# Product Change Notification (PCN)

PCN Number	510140	Date Issued	April 13, 2021
Reason for Change	Change to Product		
Change Type Description	This letter is to inform you that changes are being made to the part(s) identified in this Notice. The change may affect the fit, form, function or appearance of the parts, or it may result in a change to the specification. The pictures below show an example of the possible differences.		
Reason for Short Notice	Corrective Actions		
Assessment of Change	No change to parts/components FFF		
Internal Molex Qualification Date	April 13, 2021		
Sample Availability Date (Changed Part)	April 13, 2021		
Planned Implementation Date	April 30, 2021		
Method of Identifying Change	No special marking on the product or packaging

### Drawing maintenance for 2004851600

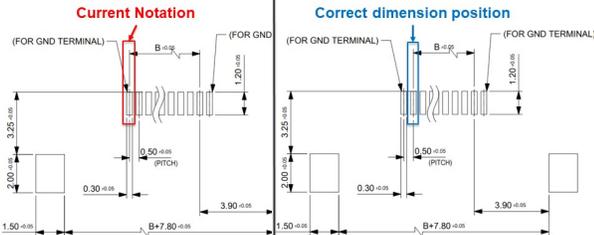
- Reason for change
  - Drawing maintenance
  - To correct the dimensional position between the pads regarding the board dimensions recommended in the sales drawing.
- Product Impact
  - No impact to Fit, Form or Function. There is no change to the product itself.
- Part Number Impact
  - See attached impacted parts list.
